STATE OF WASHINGTON  
DEPARTMENT OF ECOLOGY

April 11, 2014

**Re: Opinion pursuant to WAC 173-340-515(5) on Proposed Remedial Action for the following Hazardous Waste Site:**

- **Name:** Bellevue Corner UNOCAL 4511
- **Address:** 10605 NE 8<sup>th</sup> Street, Bellevue, WA 98004
- **Facility/Site No.:** 5569973
- **VCP No.:** NW2817
- **Cleanup Site ID No.:** 7649

<b>Perched Interval Groundwater Contour Map (May 3, 2010)</b>	
SRO, 10605 and 10619 NE 8th Street Bellevue, Washington	
	<b>Figure 5</b>

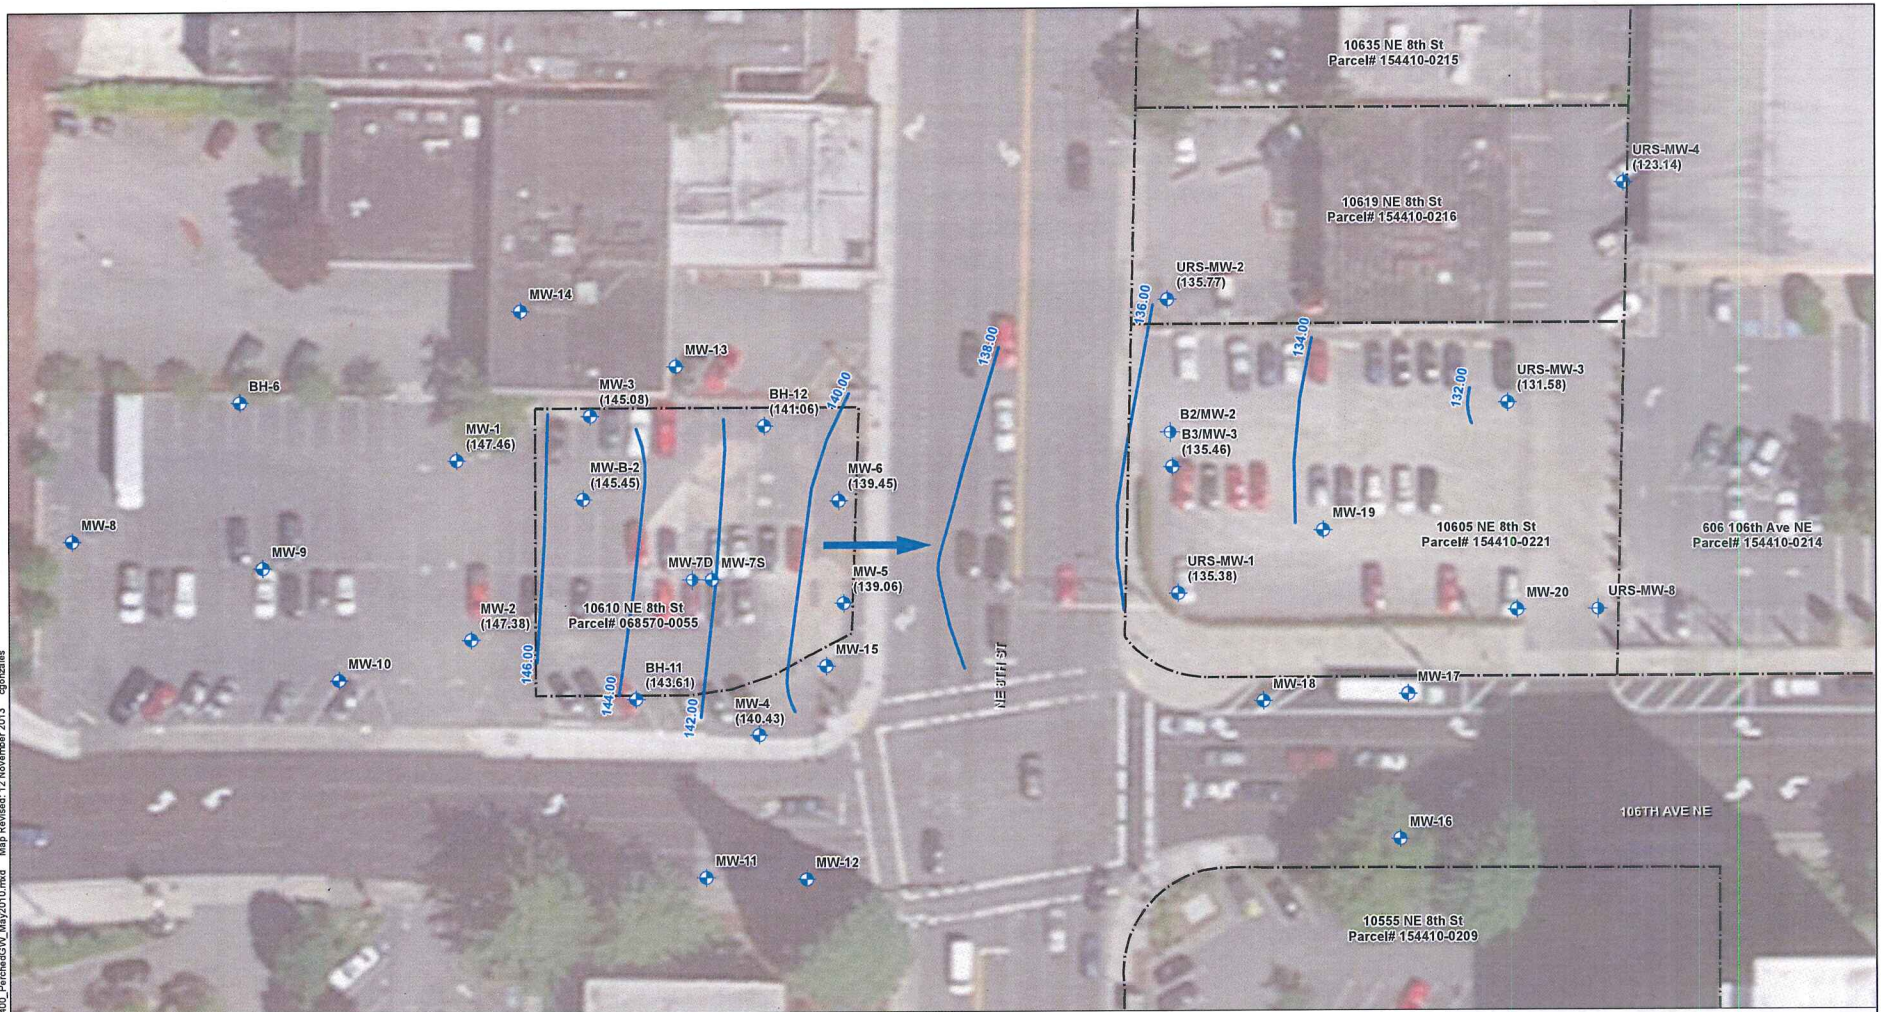
**Groundwater:** The uppermost ground water at the Site reportedly occurs as a perched zone within sand lenses in the till. This water-bearing zone occurs between 20 and 35 feet bgs, whereas static water levels in the zone are generally 22 to 30 feet bgs. The boring logs and cross-sections are not clear as to how thick the sand lenses are or their location within the inferred till unit. Lateral flow in the perched zone is to the south or southwest (**Figure 3**).

**Figure 7**

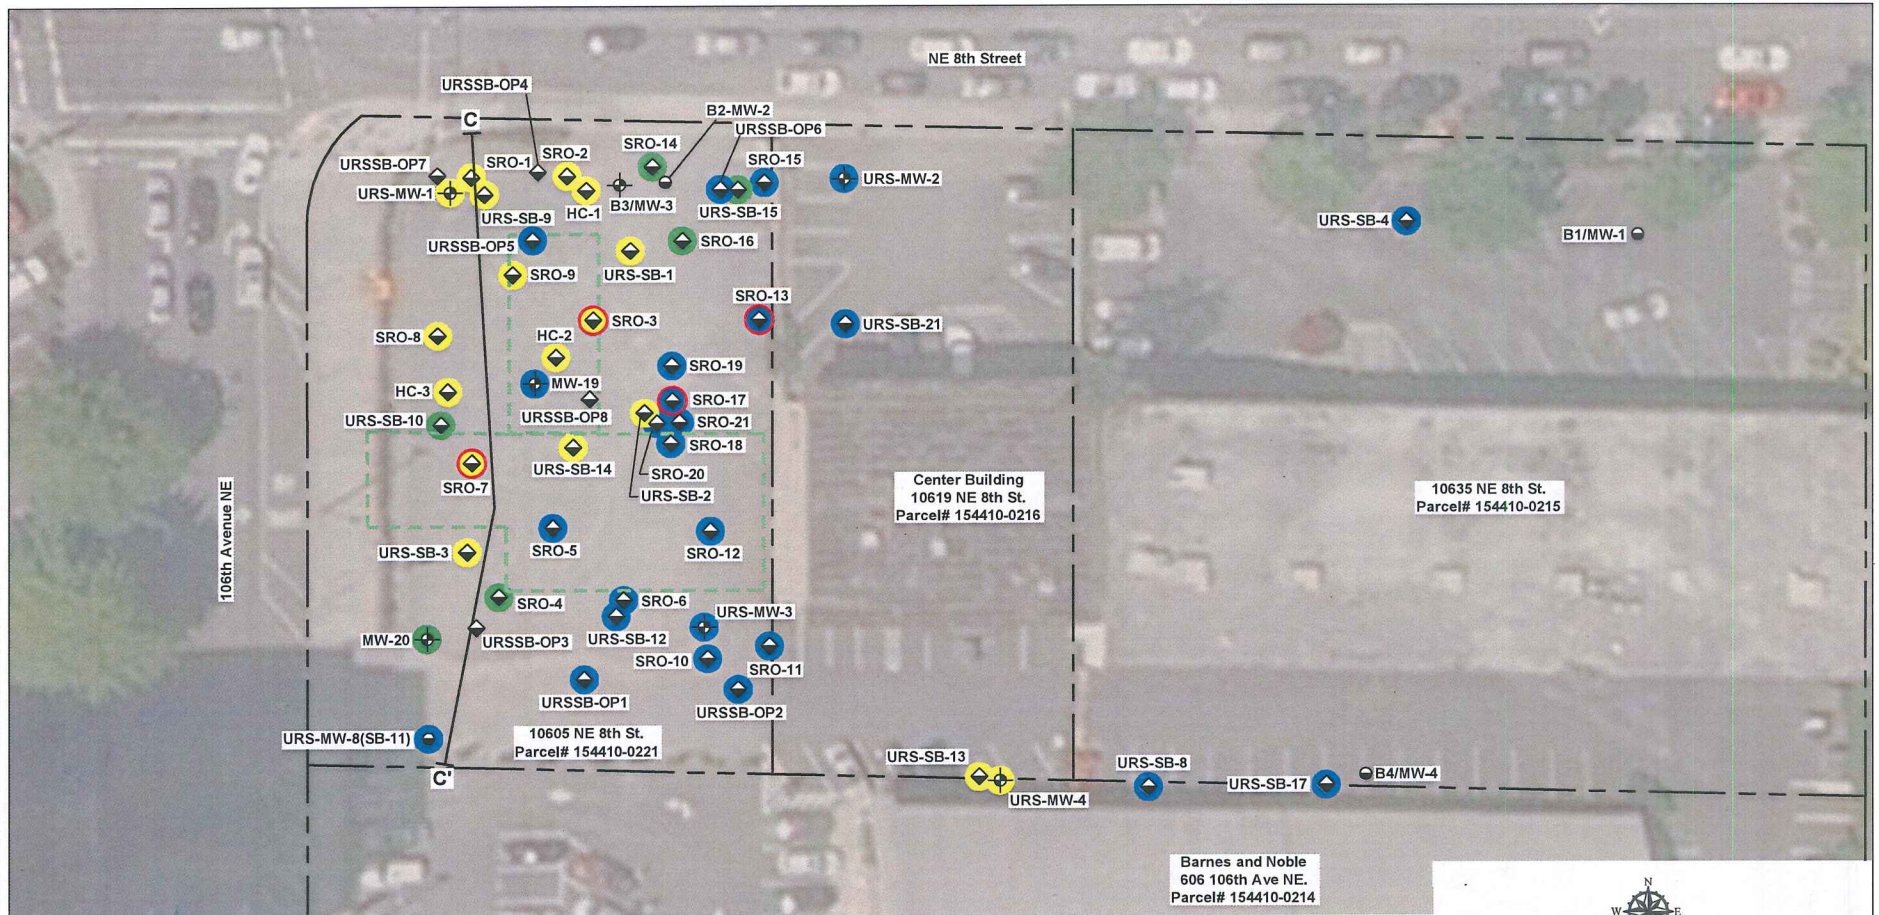
- Figures 8 and 10 have a pattern and differing color circles that need to be defined in the legend. It would also be helpful to super-impose contaminant concentrations onto the geologic cross-sections so that the relationship between Site geology and the extent of contamination is shown.
